Location:	1721 Webster Street (See map on reverse)
Assessor's Parcel Numbers:	008-0624-006-00 & -007-00
Proposal:	Proposal for a 25 story mixed use development containing approximately 250 dwelling units, approximately 5,000 square feet of office and ground floor retail.
Applicant:	Raymond Connell / Holland Partner Group
Owners:	Douglas Motor Service & Douglas Parking Company
Planning Permits Required:	Regular Design Review for new construction, Major Conditional Use Permit for development exceeding 200,000 square feet, and Vesting Tentative Parcel Map for new condominiums.
General Plan:	Central Business District
Zoning:	CBD-C / Height Area 7
Environmental Determination:	Determination Pending
Historic Status:	Not a PDHP; Rating: D3
City Council District:	3
For further information:	Contact case planner Pete Vollmann at 510-238-6167 or by email: pvollmann@oaklandnet.com

CITY OF OAKLAND PLANNING COMMISSION

Case File: PLN16445
Applicant: Raymond Connell
Address: 1721 Webster Street
Zone: CBD-C

DESIGN REVIEW

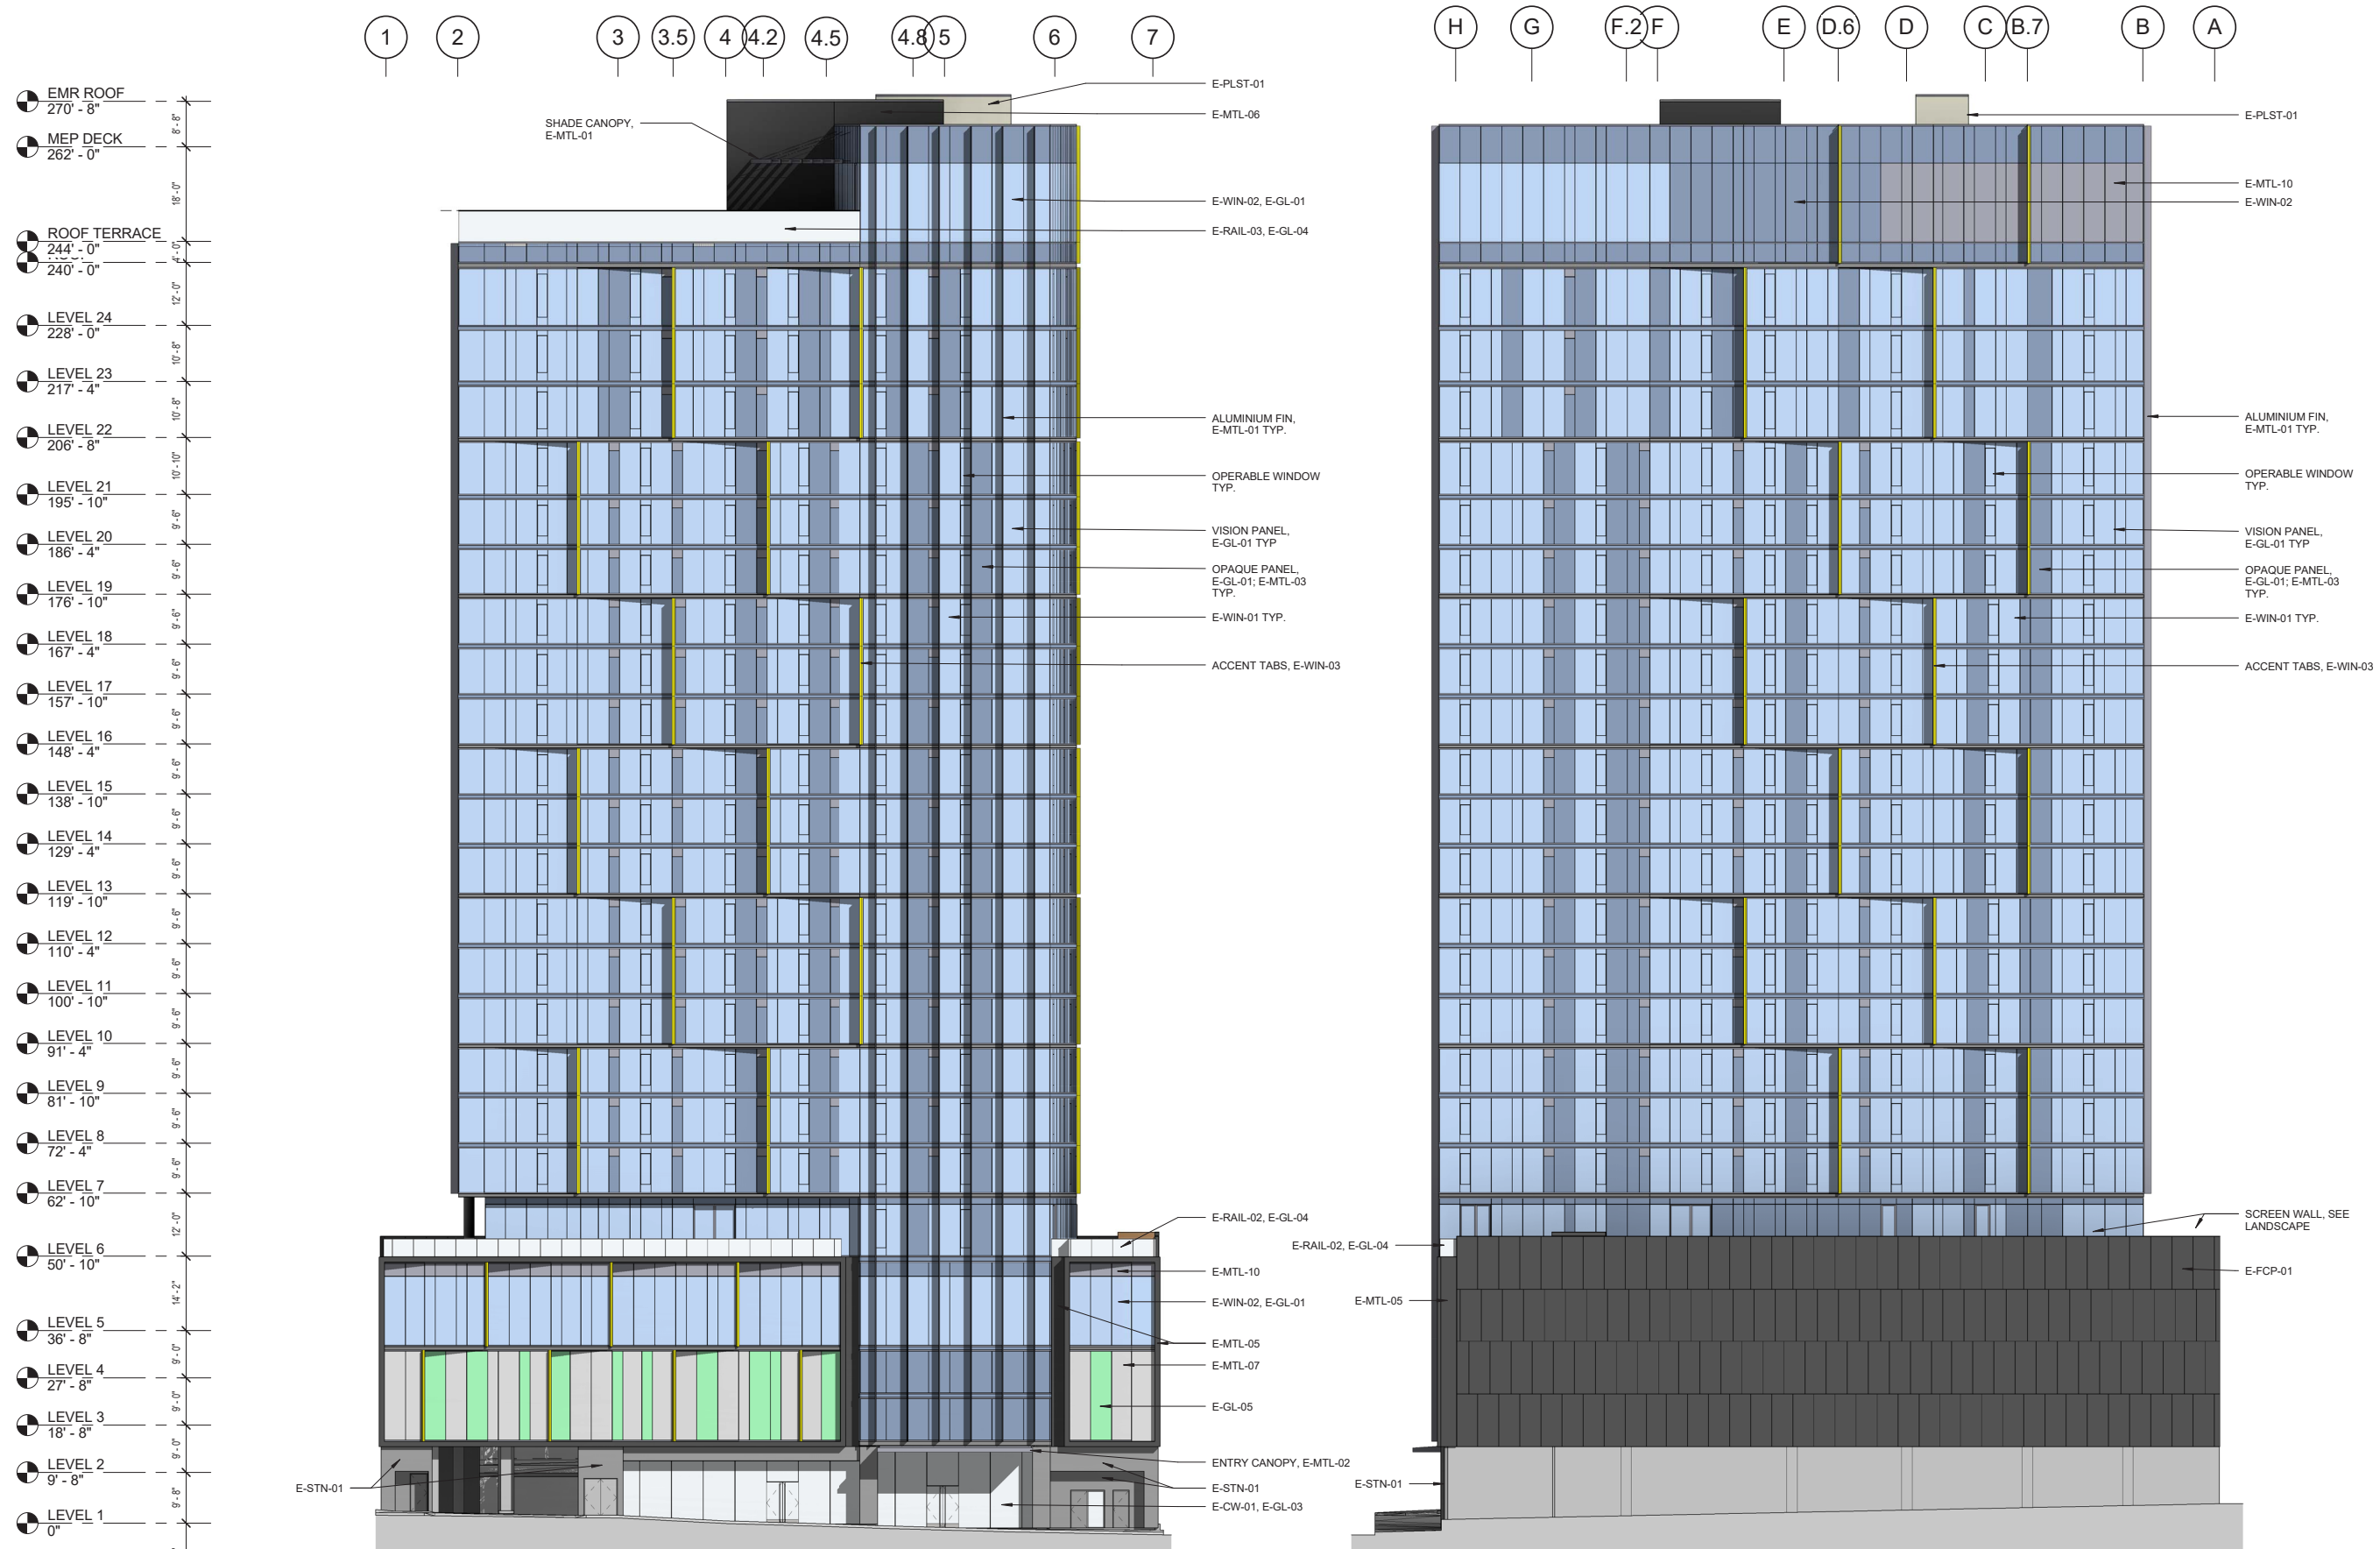
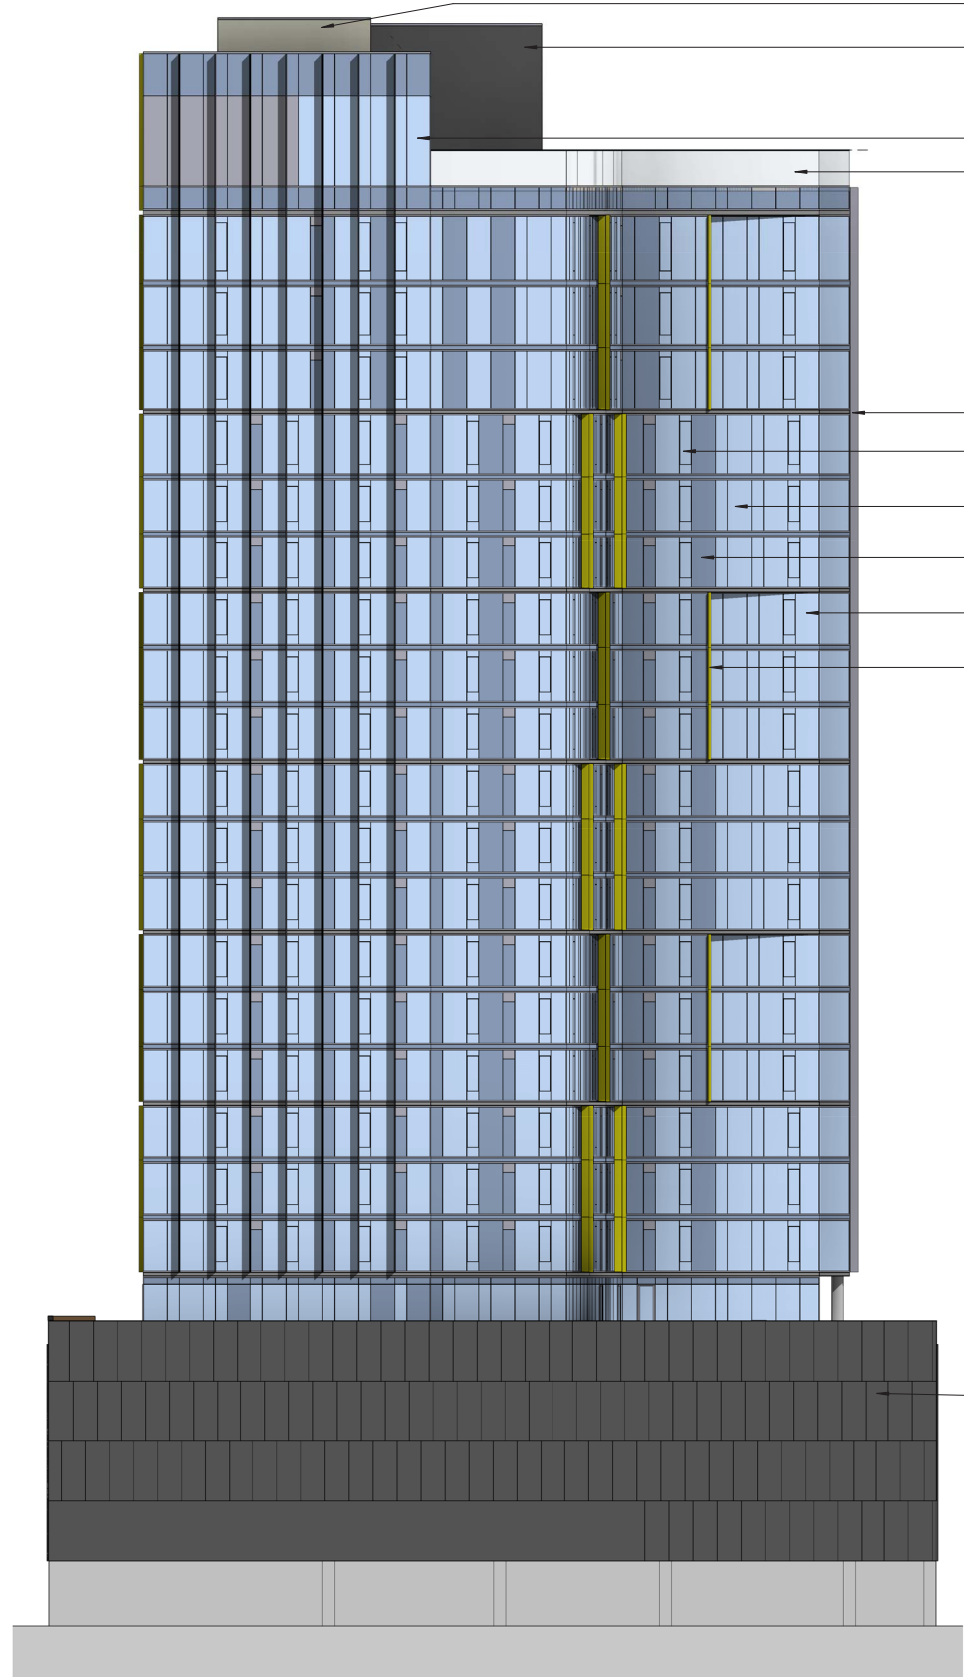
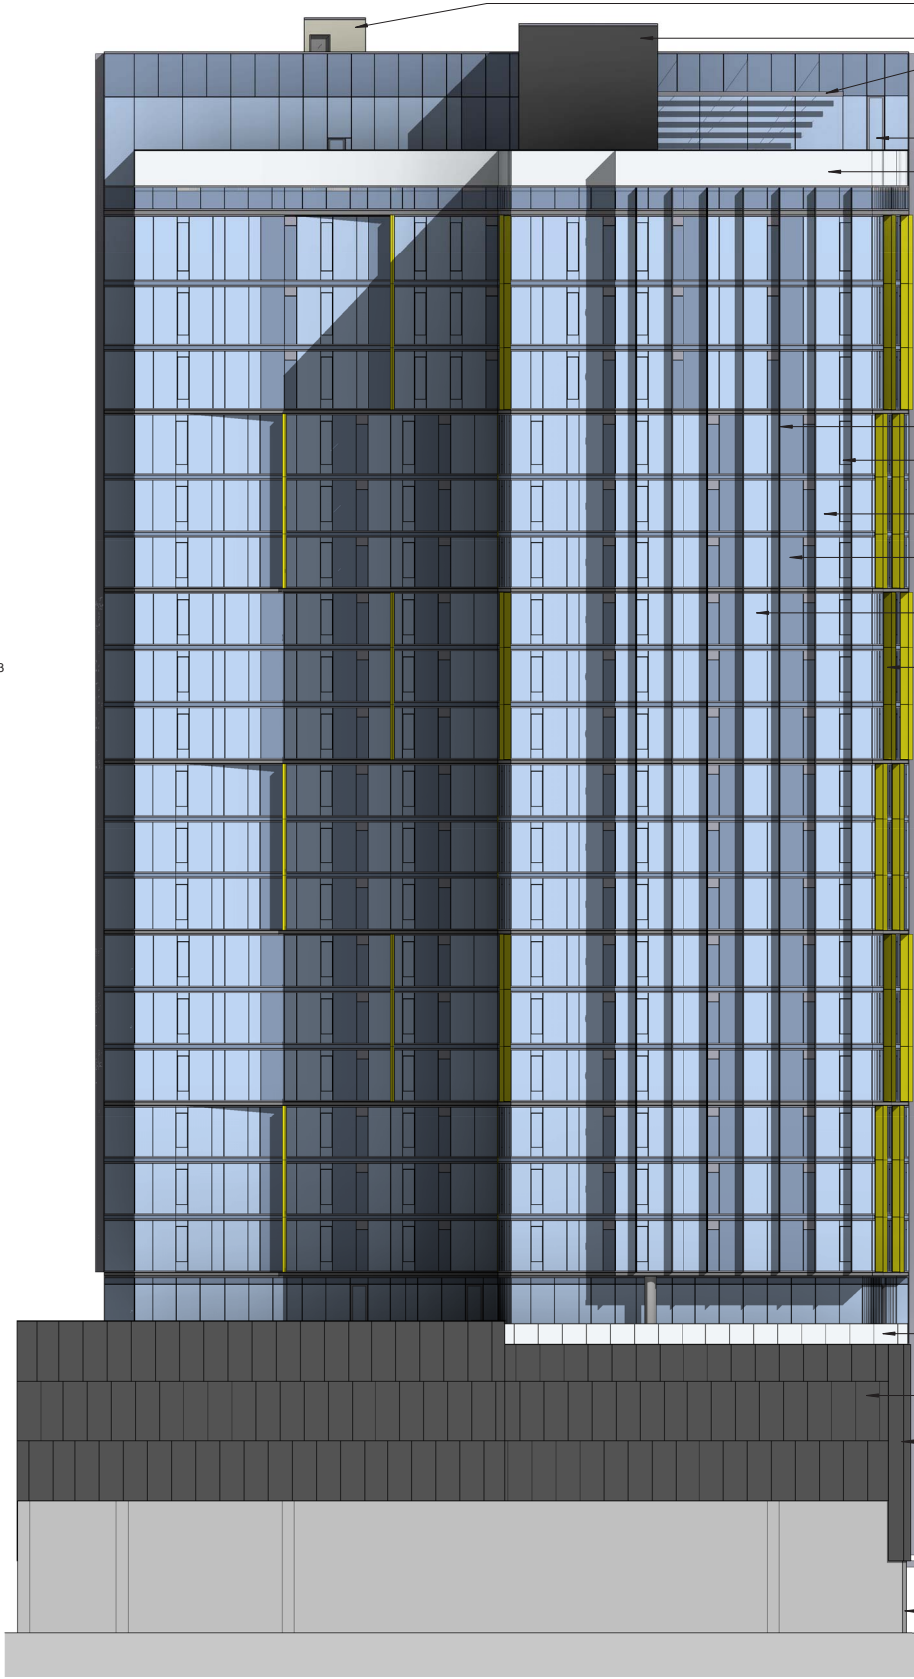
Vertical Accent Panels

Throughout the exterior of the project there are vertical yellow accent panels. While staff often does not comment on specific colors of finished building materials, the bright yellow fins are of concern. The material is used at the base of the building façade as well as in the return of the glazing recesses that create the basket weave look to the building façade. Staffs concern is that the yellow accent panel while seemingly meant to add attention to the glazing recesses it may somewhat diminish them since the bright yellow clashes so much with the glazing and it could look dated quite quickly and possibly take away from a more timeless design of the tower.
